**RE: DRAFT 2014 APARTMENT DESIGN GUIDE AND AMENDED SEPP65**

## 2014 DRAFT APARTMENT DESIGN GUIDE & AMENDING SEPP 65

### KEY COMMENTS AND RECOMMENDATIONS

SUBMISSION TO THE NSW DEPARTMENT OF PLANNING AND INFRASTRUCTURE

*Example: Harold Park, Sydney*

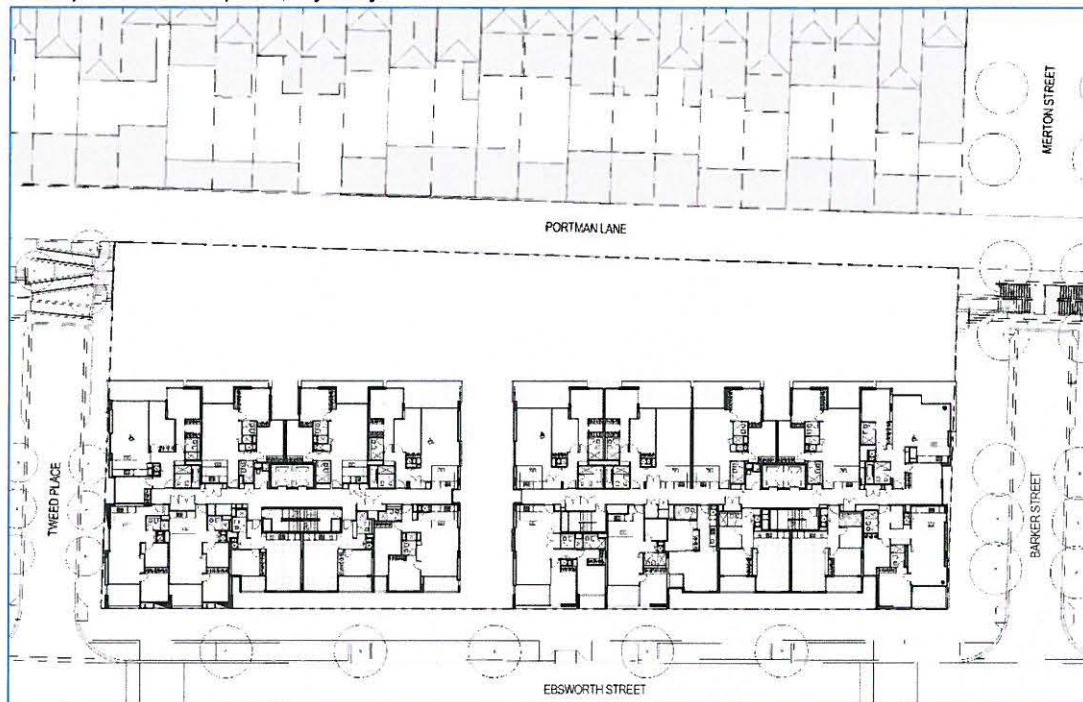
- Current apartment planning provide 9.6m deep apartments allowing for 4m living, 3m dining and 2.6m kitchens (with benches) as an industry standard and expected by the market. The proposed 6.75m depth will reduce amenity with smaller living and dining rooms and kitchens located to the side of living areas, or buried within apartments. The limitation will increase apartment frontages resulting in a decrease in apartment yield and increased apartment cost to recoup land costs.
- Kitchens typically require bulkheads for service transfers and air conditioning systems reducing the ceiling/bulkhead height to 2.45m. The proposal will increase this to a minimum 2.7m resulting in the general ceiling height of apartments to be 2.95m.
- The control limits planning outcomes and diverse apartment plan solutions.

*Room depths are 9m and 8.5m to the back of kitchens.*

- Under the proposed amendments these typical apartments will require ceiling heights of 3.45m and 3.6m which is excessive and will reduce the number of floors within building height controls, reducing apartment yield and increasing apartment cost.

- Commence room depth ratio to 9.6m at a 2.7m ceiling height, or
- Increase depth for north, northeast and northwest facing apartments to 9.6m at 2.7m ceiling height with remaining orientations being 8.5m deep at 2.7m ceiling height.
- Allow for bulkheads for services below the acceptable ceiling heights.
- Include a sliding scale based on frontage, i.e. wider frontage allows deeper apartment.
- Amend text to provide a concession where there is a side window within the depth of the apartment (For corner apartments why is there any limit on room depth where access to light is achieved from side windows).
